Lufttüchtigkeitsanweisung Consigne de navigabilité Prescrizione di aeronavigabilità **Airworthiness directive**

HB 92-403

FFA FLUGZEUGWERKE ALTENRHEIN AG - Model AS202/18A, /18A1, /18A2, /18A3, /18A4 aircraft, serial numbers up to and including S/N 236.

Improved Fuel Gravity Feed Hose

1.8 Tooling

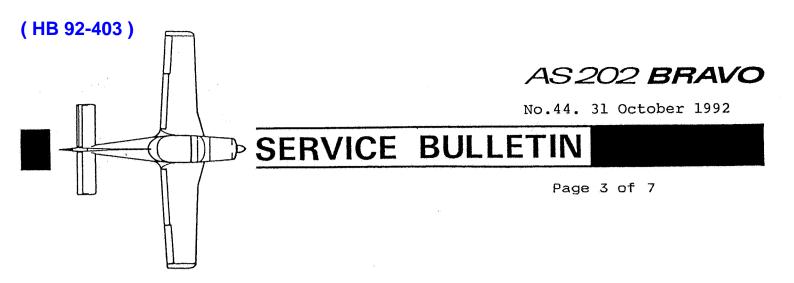
Standard tools, and facility for reworking rigid pipe as per diagram. (If rework facilities are not available, replacement parts may be ordered from FFA on an exchange basis).

Service Bulletin 44. Page 5 of 7

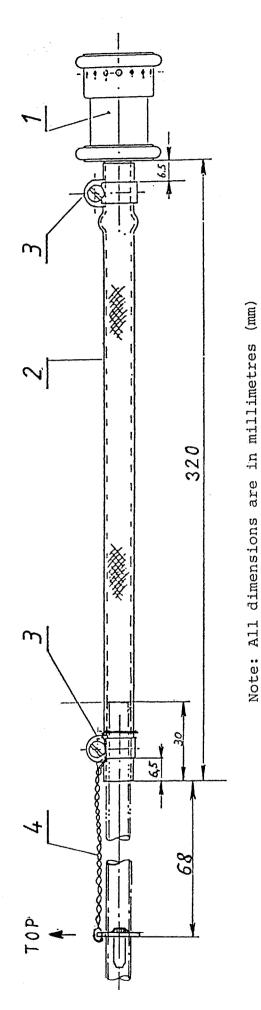
- 2.7 Assemble the new flexible hose assembly to the dimensions on the accompanying diagram on page 5, using the clamps and intake valve retained in step 2.5.
- 2.8 Refit the flexible hose assembly and sensor unit.
- 3. <u>Material</u>

- Drill one 2mm hole in the attaching plate as per the 4.7 accompanying diagram on page 6.
- Assemble the new flexible hose assembly to the 4.8 dimensions on the accompanying diagram on page 5 using the clamps and intake valve retained in step 4.5. Secure the flexible hose by attaching locking wire from the clamp to the 2mm hole in the fuel pipe attaching plate.
- Refit the flexible hose assembly and sensor unit. 4.9
- 5. Material

Aeroquip 701-6 Mikroflex Nr.2 AISI302 0.8 mm Intake valve assy 202-18.721 10-0 • 1 Flexible hose 6.5 Locking Wire i Clamp - FOR AIRCRAFT AS202/18A1/18A2/18A3/18A4 ŋ 4 -1 2 3 202-18.722 \sim 320 Fuel Gravity Feed Hose Assy. \mathbf{n} 2 5.5 1

Service Bulletin 44. Page 6 of 7

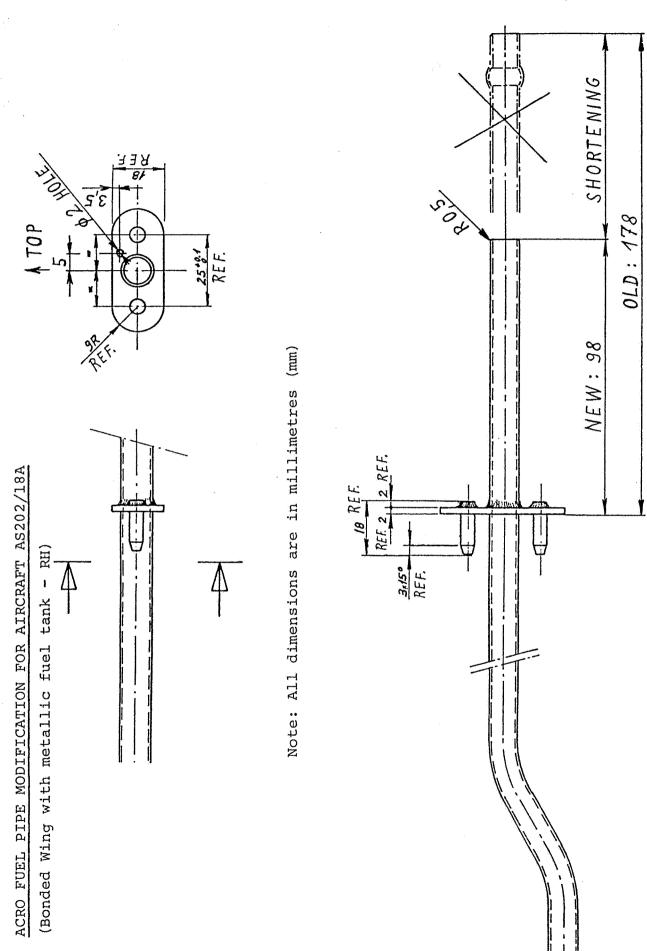
- Procedure for AS202/18A aircraft. (Bonded Wing with metallic fuel tank).
- 4.1 Drain fuel from right side fuel tank.
- 4.2 Remove the fuel level sensor from the right side fuel tank, having first ensured that the relevant circuit breakers are OFF.
- 4.3 Disconnect the rigid Acro fuel pipe from the tank wall fitting and detach the spigots from the pipe support assembly.
- 4.4 Remove the pipe assembly through the level sensor access hole.
- 4.5 Disassemble, and discard the old flexible hose and spring. Retain the intake valve and clamps.
- 4.6 Rework the original pipe as per the attached drawing on page 6. (This involves shortening the tube by 80 mm.) Remove any burrs.
